Docket Number:	24-OPT-05
Project Title:	Corby Battery Energy Storage System Project
TN #:	262554
Document Title:	Project Description Update
Description:	Updated Project description with associated environmental analyses.
Filer:	Doug Urry
Organization:	Tetra Tech
Submitter Role:	Applicant Consultant
Submission Date:	4/2/2025 11:23:24 AM
Docketed Date:	4/2/2025

Project Description Update

Corby Battery Energy Storage System Project

April 2025

Figure 3.14-1. Construction Personnel by Month (Replaces Figure 4.14-1 in Application)

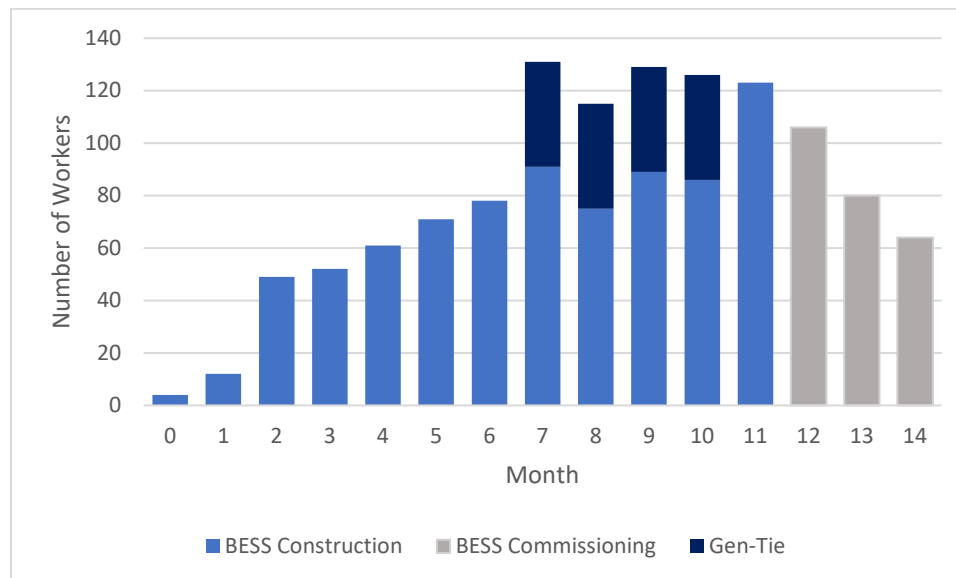
An additional 4 workers will be added in months 0 and 1, and 26 additional workers will be added during months 9 to 12. These additions to the construction and commissioning workforce are not expected to affect the findings in the Application with respect to construction-related impacts to population, housing, and fiscal resources.

**Figure 2-4
Irrigation Canal
Temporary Water Supply
Conceptual Layout**

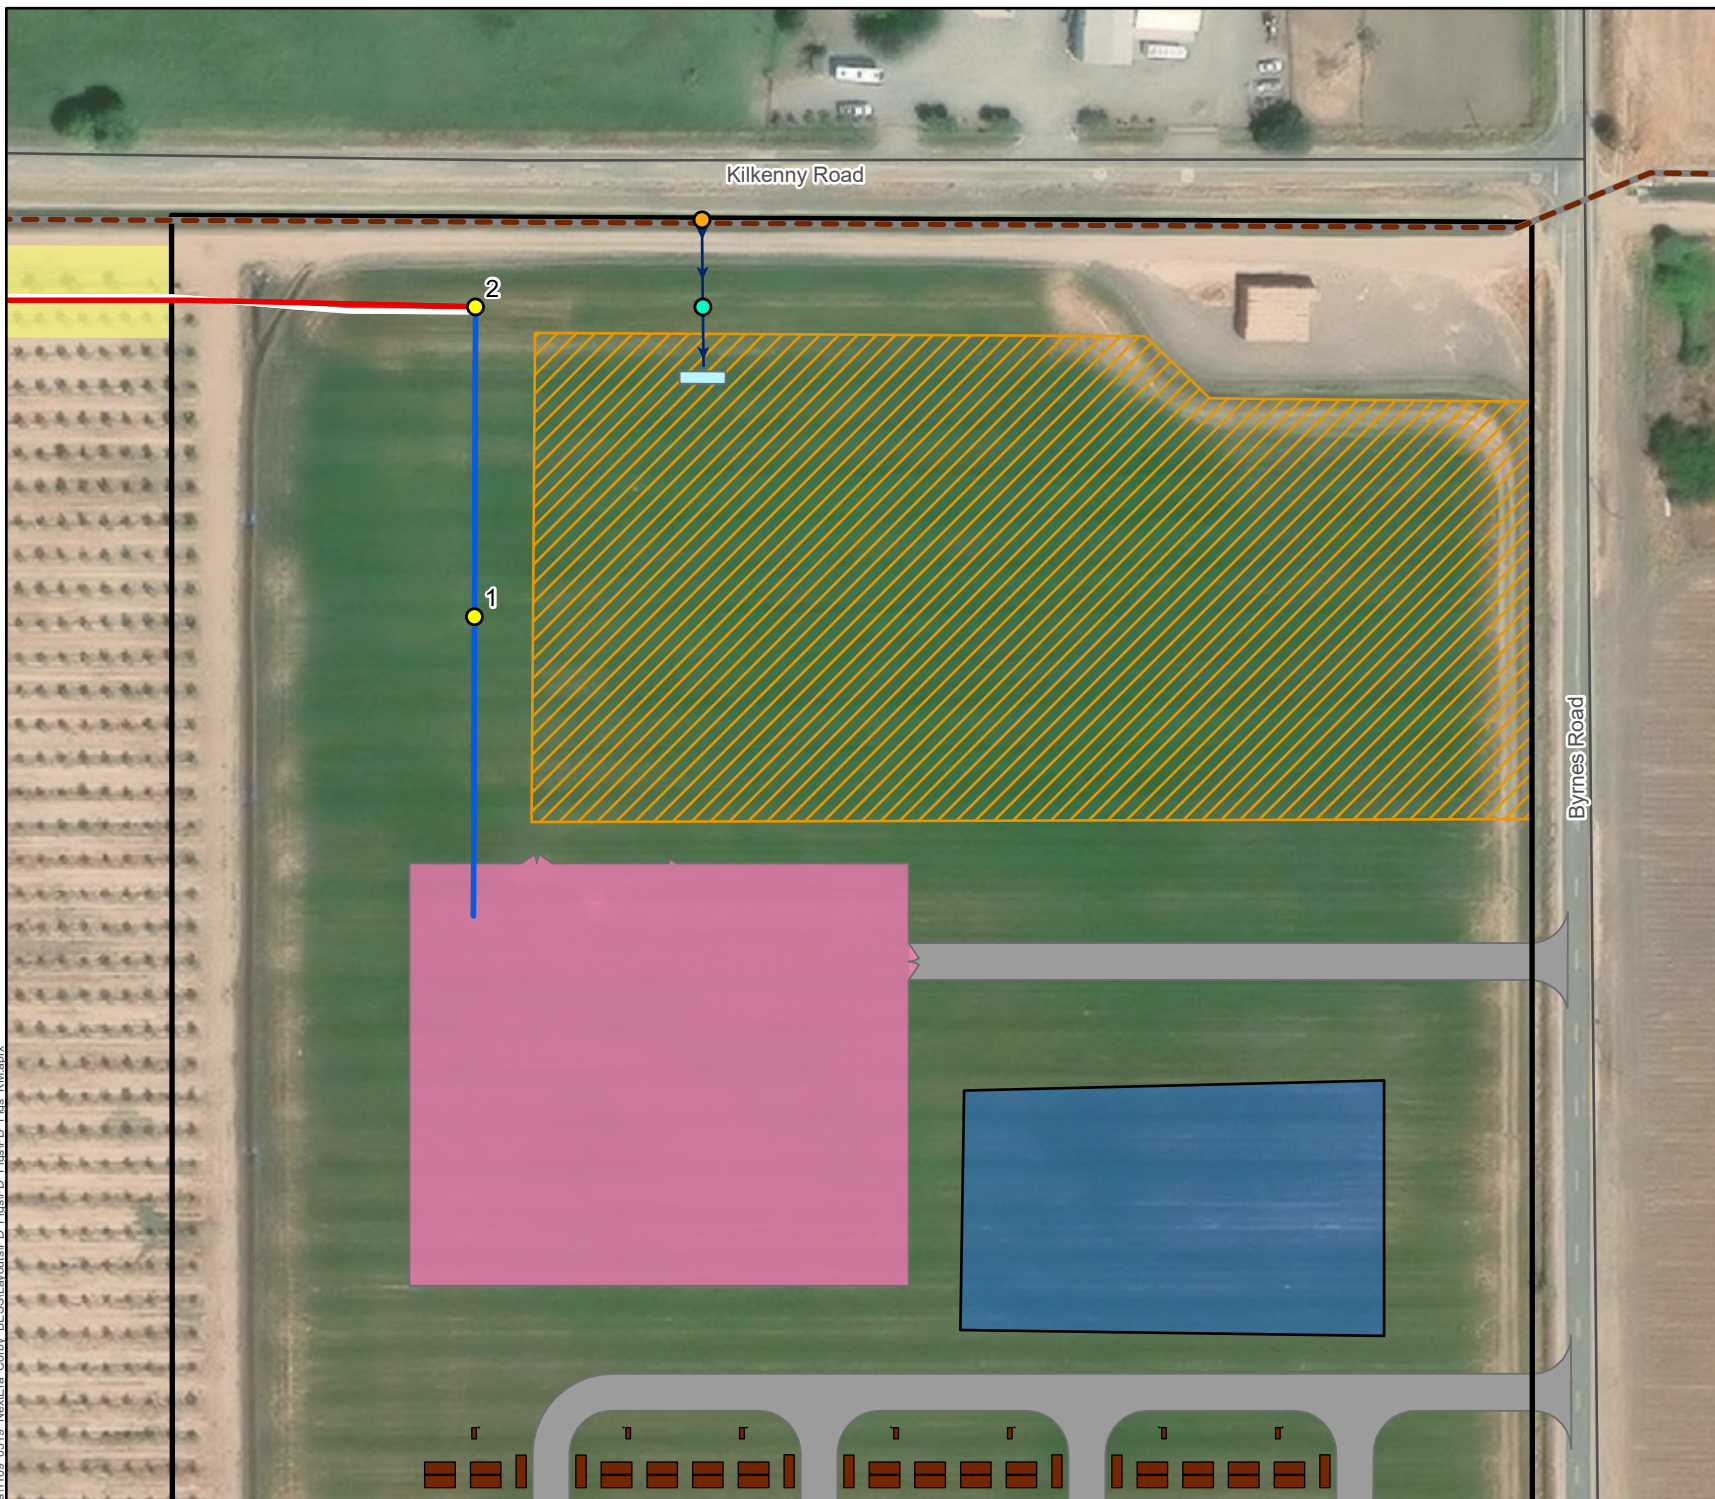
An east-west oriented unlined irrigation canal is located within an SID easement between the Project site and Kilkenny Road. The canal is approximately 3 feet deep and 10 feet wide based on site topographic survey data, aerial imagery, and site reconnaissance documentation. SID distributes water to irrigation users during the irrigation season, which varies annually but is typically April through October.

If canal water is available and approved for construction use by SID at the time of construction, the construction contractor will withdraw water from the canal using a temporary pumping, conveyance, and storage system. The system will include an intake screen, flexible pump intake hose, pump, shutoff valve, flexible conveyance hose, and a temporary storage tank located approximately 100 feet south of the canal within the construction laydown area. Alternatively, the water may be pumped directly into water trucks in lieu of using a temporary storage tank. The system will be manually operated as needed to fill the temporary water tank or water trucks throughout the construction phase. A conceptual layout showing the system components and approximate location is provided in Figure 2-4. A similar system could be used to fill water trucks for landscape irrigation during the first 5 years of operation, if necessary.

A 5-horsepower (hp), 245 gallon per minute (gpm), gasoline-powered centrifugal pump has been conservatively assumed for the purposes of the updated environmental analysis (pump specifications are provided in Appendix 2-B). The pump will be placed within secondary containment at least 50 feet from the canal.
